Submission of Further Information

**Proposed Temporary Warehouse (excluding Dangerous Goods Godown) with
Ancillary Office and associated Filling of Land for a Period of 3 Years
Lots 29 (Part), 33 (Part) and 35 (Part) in D.D. 111
and Adjoining Government Land, Pat Heung, Yuen Long
(Application No.: A/YL-PH/1077)**

Comments from Drainage Services Department dated 20.1.2026

Map A

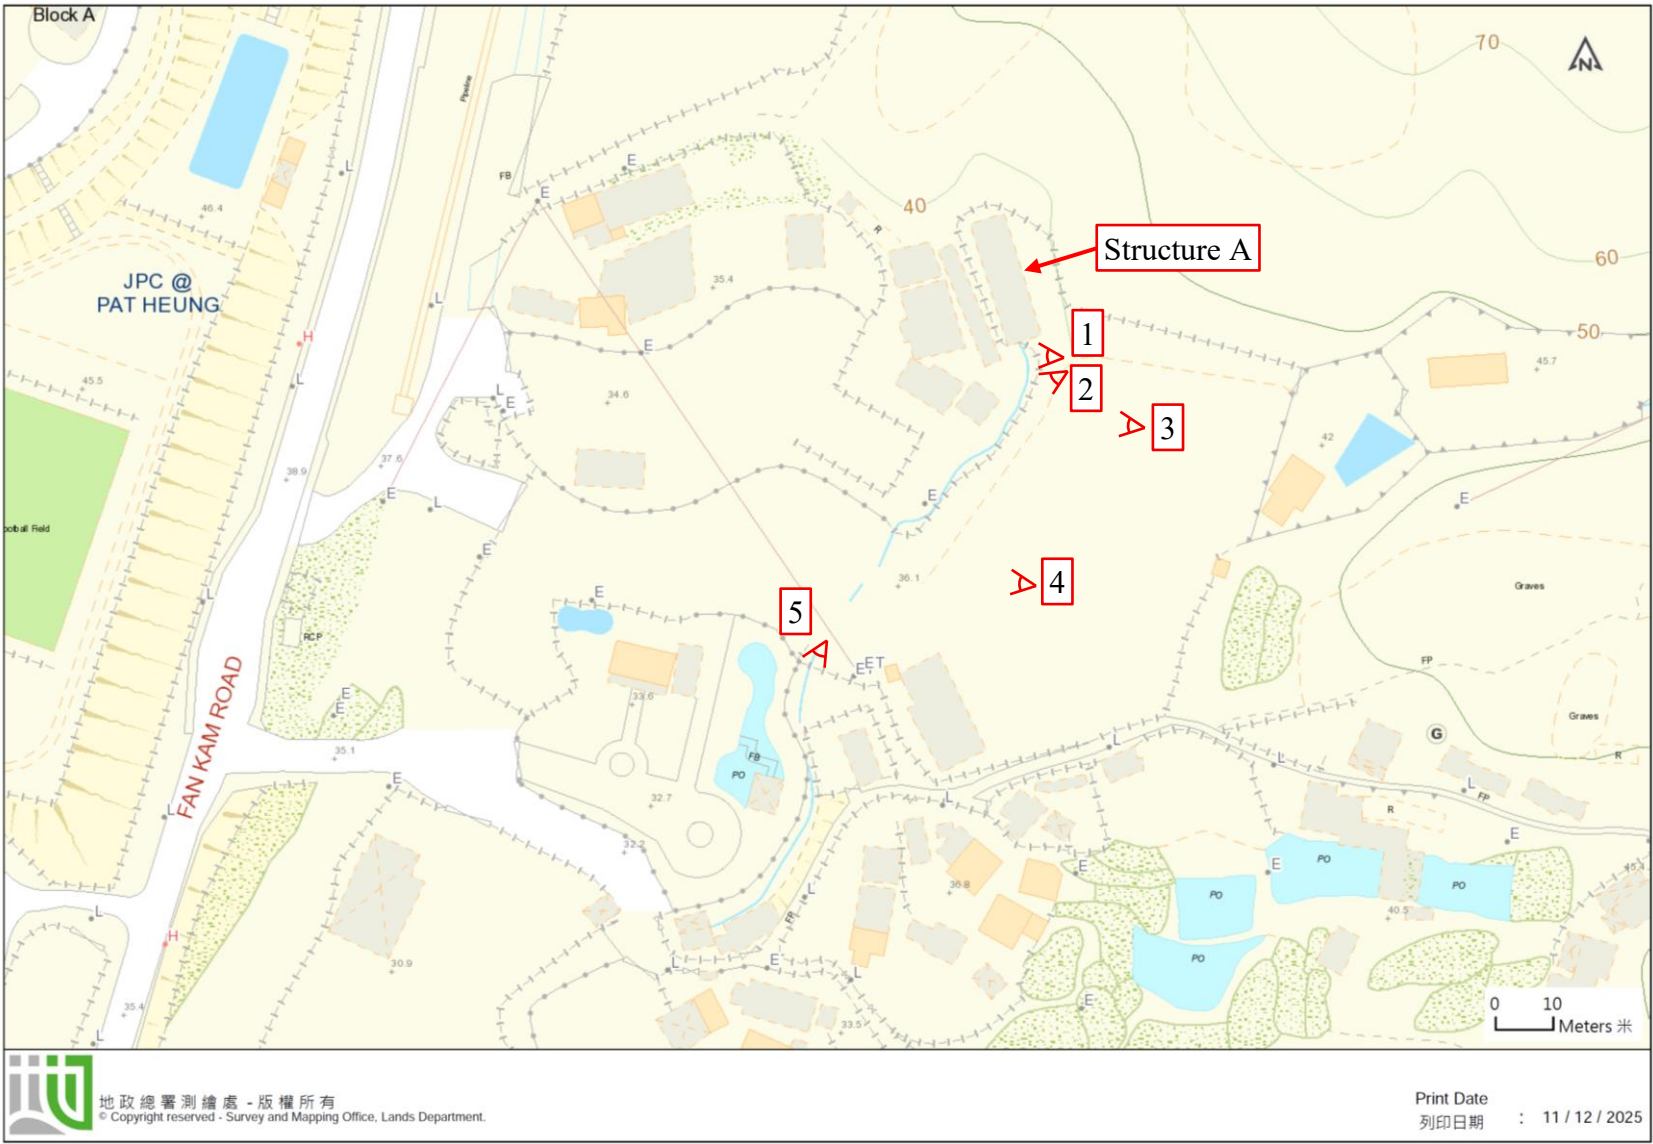
Comments	Responses
i.	It is noted that the site area is 5285m ² and the ground to the north of the application site is generally higher. Since the overland flow from the adjacent lands shall be probably intercepted, external catchment shall be considered in the calculation (i.e. Lots 22, 24, 25 and 26, etc. in D.D. 111). Please also make reference to the latest Technical Note No. 1 issued by DSD for more details in preparing the drainage proposal. Please upgrade all drainage facilities size accordingly.	<p>The ground level of the ground to the north is +34.6mPD as shown in Plan 6.1b. The ground level of the western side of the application site is +36.5mPD. Thus, the ground to the north of the application site is lower than the application site.</p> <p>The U-channels within the site are upgraded to 600mm. Please refer to Plan 6.1b.</p>
ii.	Referring to R-to-C, please advise whether any section of the said local ditch is within the application site. If affirmative, please ensure that the existing local ditch and the relevant discharge connection(s) should be maintained due to the proposed development. Please also provide adequate measures and drainage facilities to intercept their flow properly. Please indicate the above on the drainage plan for reference.	No section of the said local ditch is within the application site. Please refer to attached site photographs and Plan 6.1b for the viewpoints of the photographs.

Comments	Responses
v.	Please indicate clearly the full alignment of the discharge path from the application site all the way down to the ultimate discharge point (e.g. a well-established stream course/public drainage system).	Please refer to attached photographs.
vi.	The existing 500 mm u-channel, to which the proposed to discharge the stormwater from the subject site was not maintained by this office. Please resolve any conflict/disagreement arisen for discharging the runoff from the application site(s) to the proposed discharge point(s). Moreover, please ensure that this drainage system and the existing downstream drains/channels/streams have adequate capacity to convey the additional runoff from the application site(s). Regular maintenance should be carried out by the applicant(s) to avoid blockage of the system.	Noted.
vii.	Further to (vi) above, since there is no record of the said discharge path, please provide site photos to demonstrate its presence and existing condition.	The discharge path is updated to discharge to an existing catchpit where there are 2 nos. of 1m underground pipe. Please refer to Plan 6.1b and viewpoint photographs 6 and 7.

Site visit reveals that there is no streamcourse running from the door of the structure as indicated in Map A.
